ADDENDUM NO. 3

Date: August 21, 2023

Issued by: Sacramento City Unified School District

Project: **Project #: 0510-465**
0510-465 CKM/Fern Bacon/Matsuyama/Parkway/Rosa Parks and Sutterville
Security Improvements: Group 2

SHEET NO.
C1.0.2

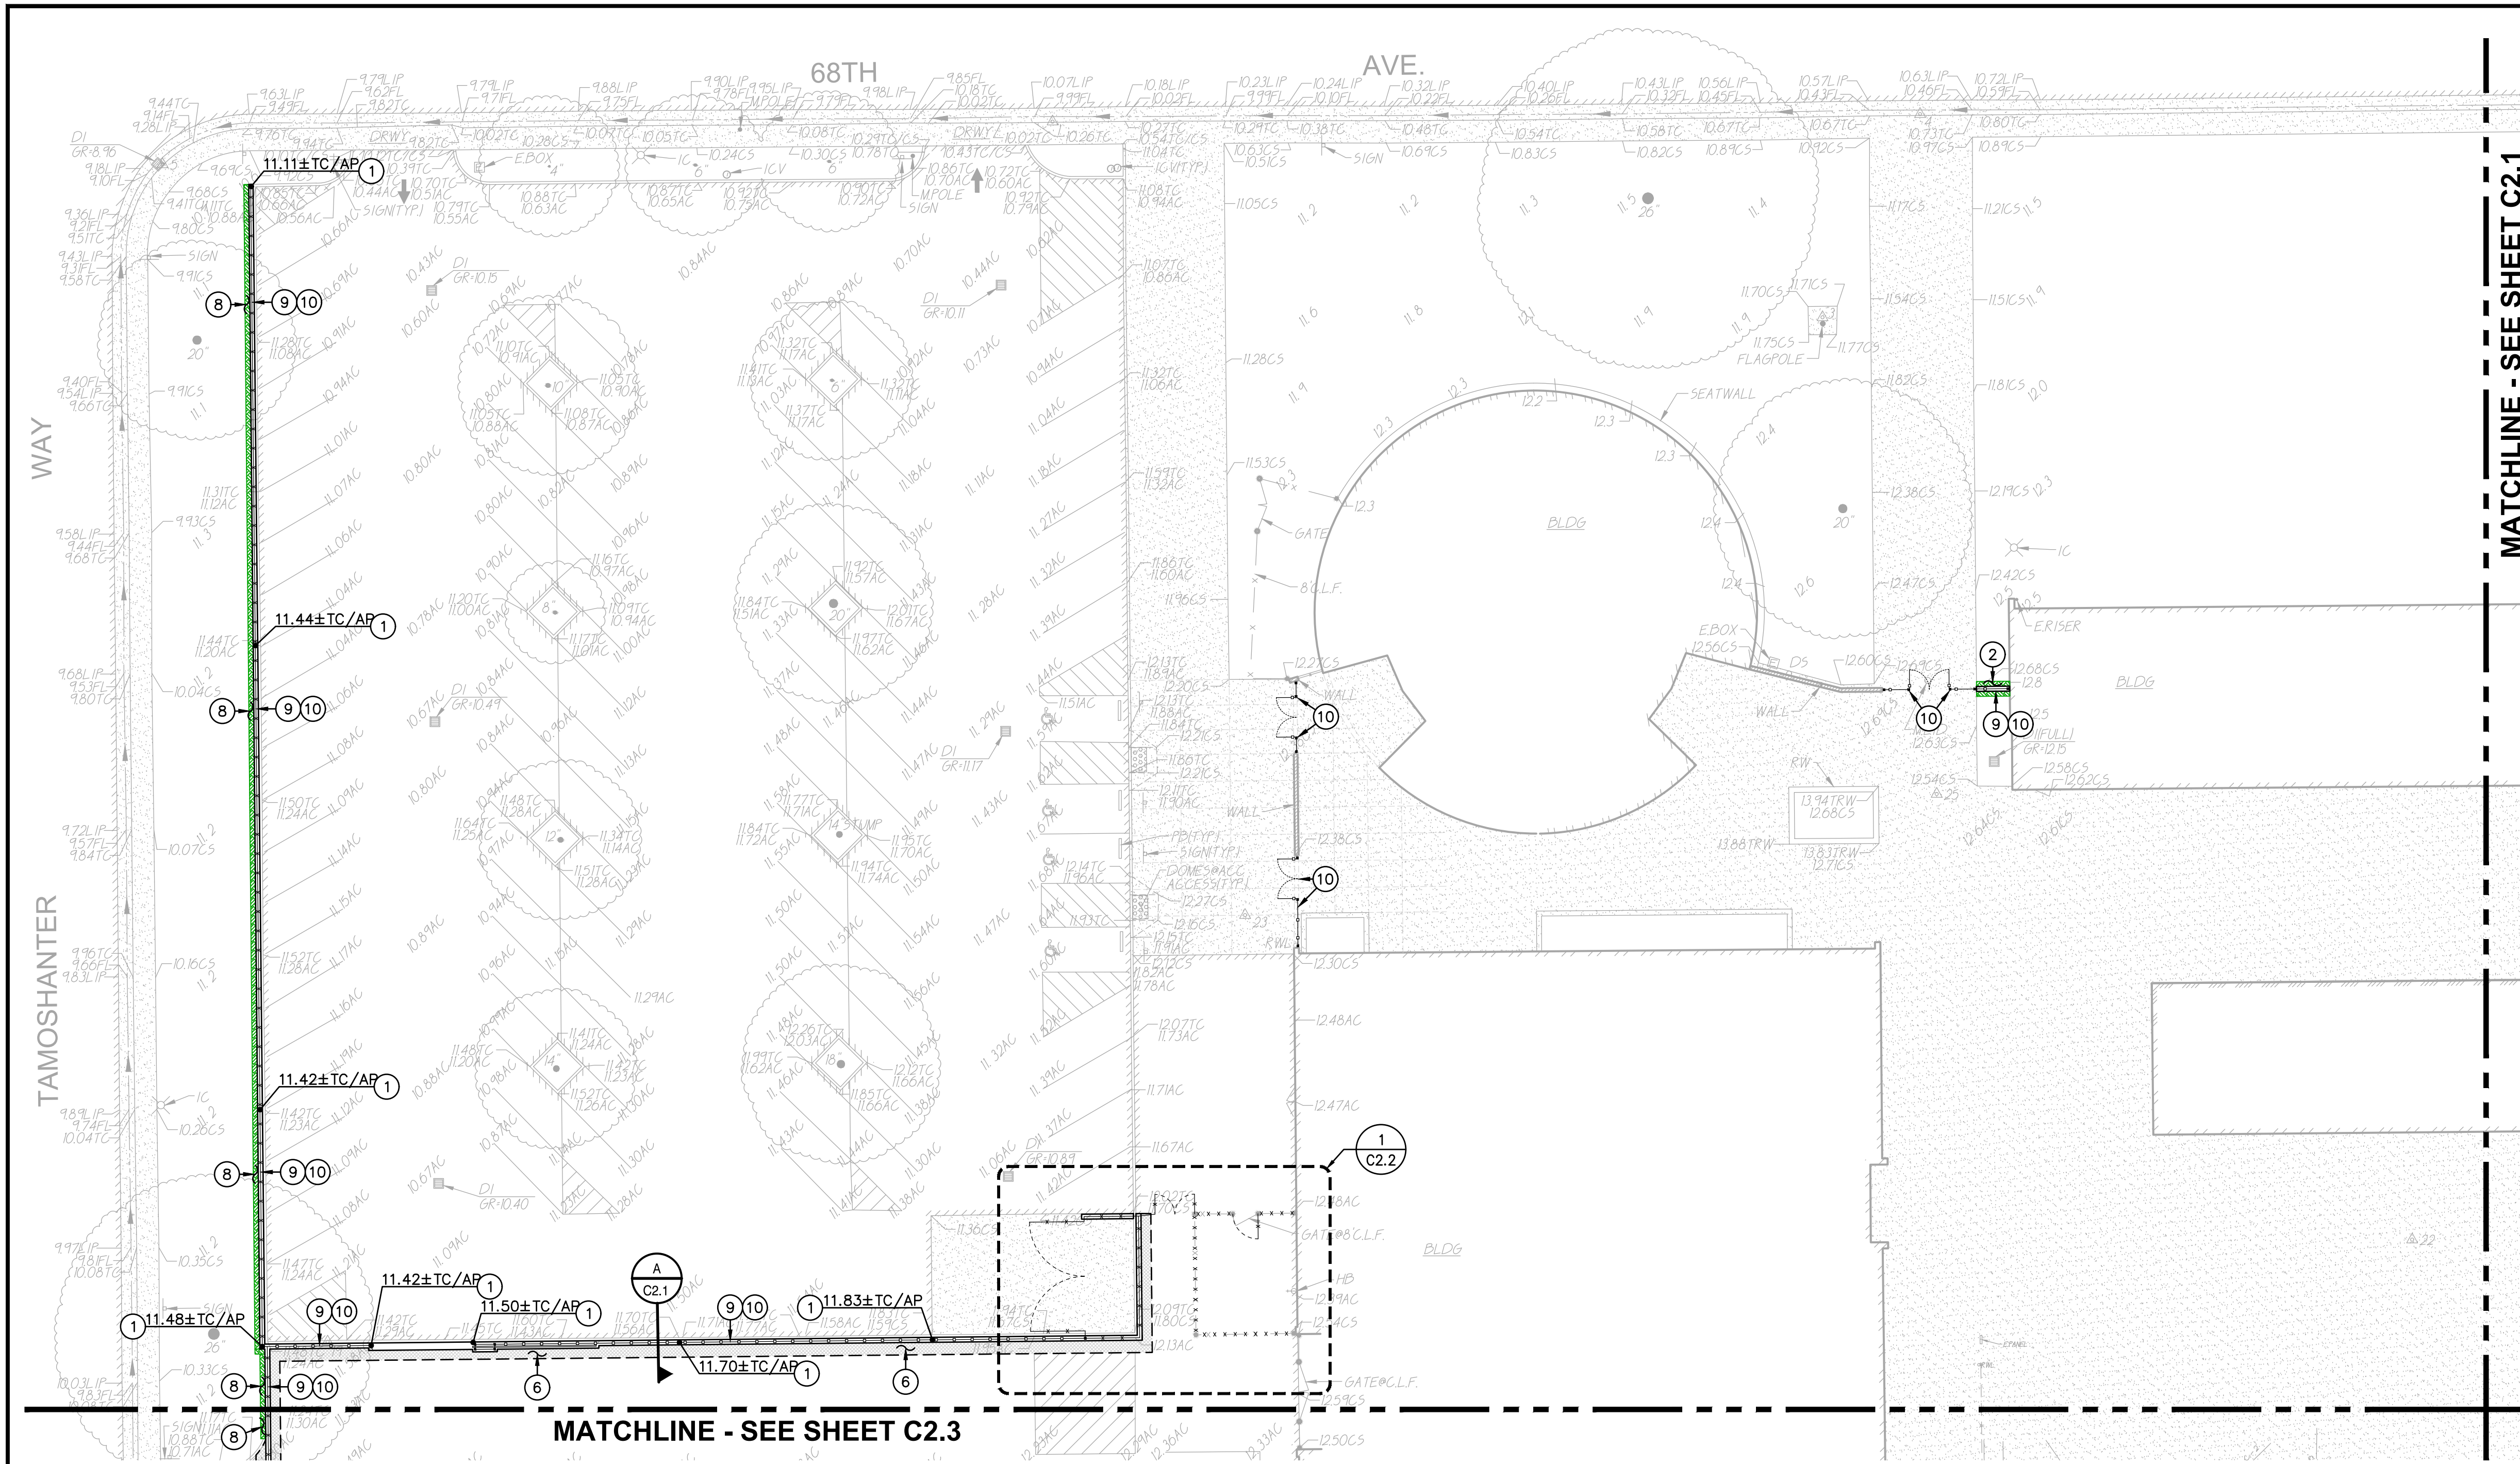
Sheet C1.0.2

- Site fire plan updated with additional references.
- Multi-purpose egress analysis provided.

SHEET NO.
C1.0.2

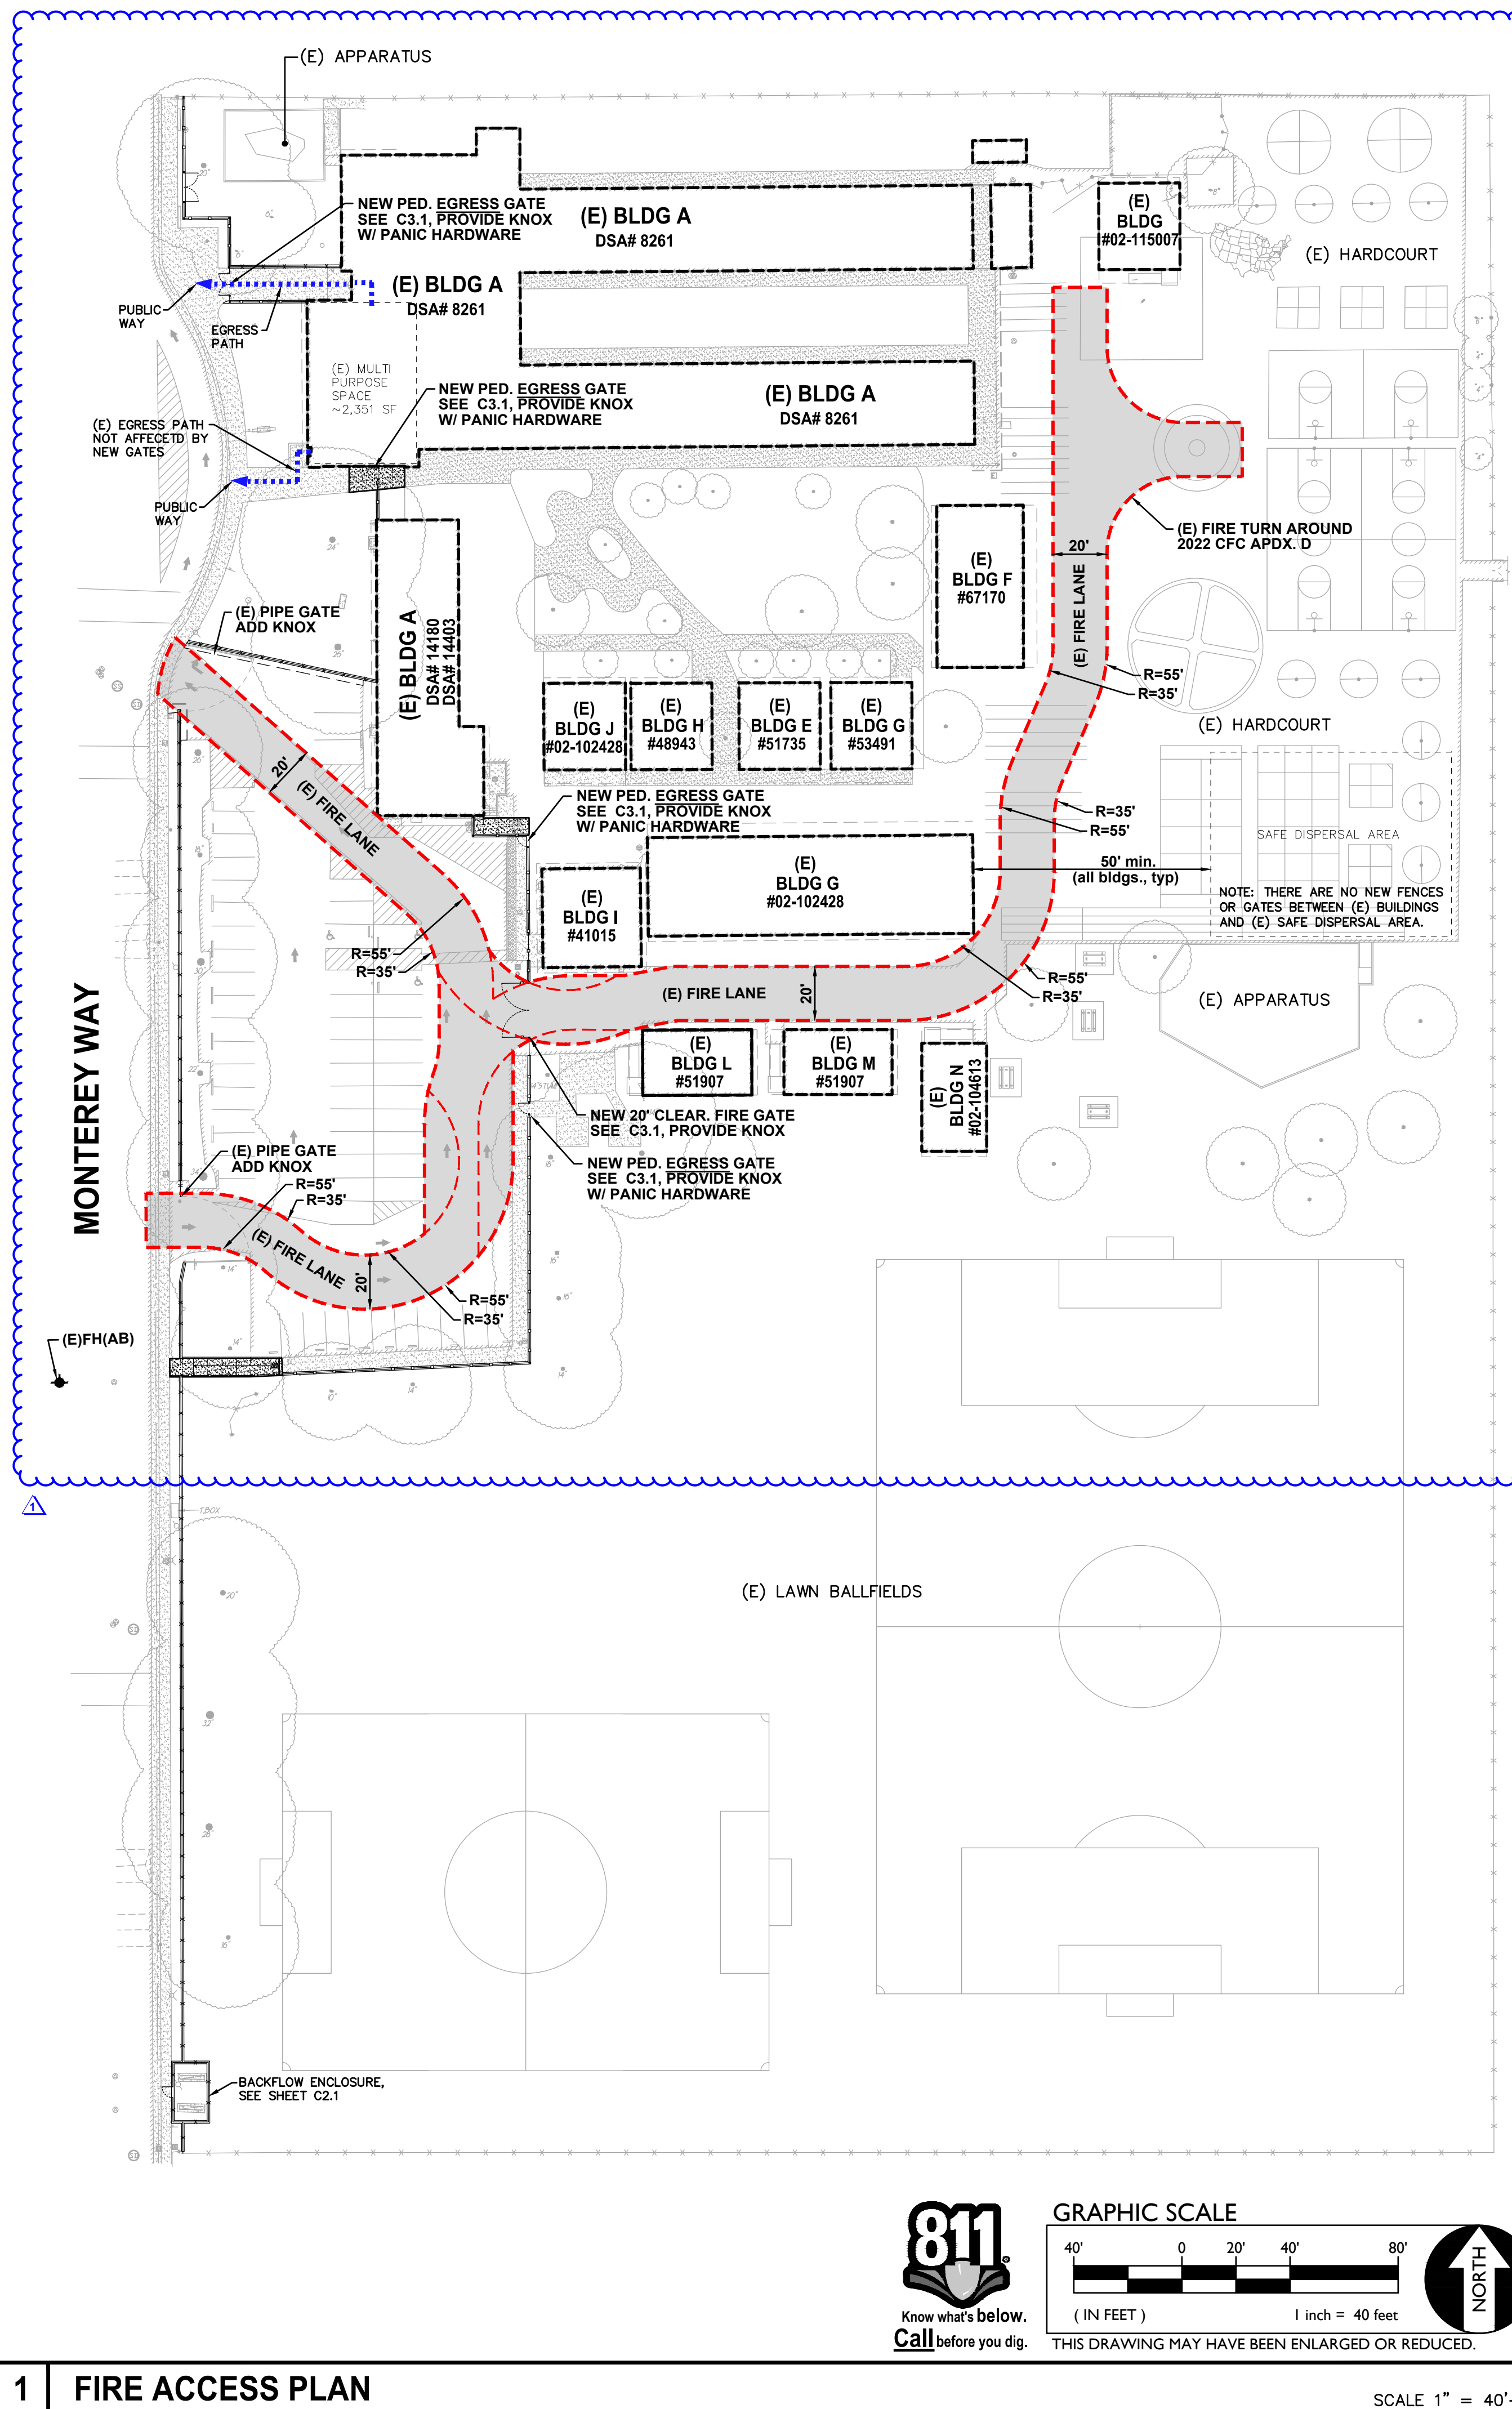
Sheet C1.0.2

- Site fire plan updated with additional references.
- Multi-purpose egress analysis provided.
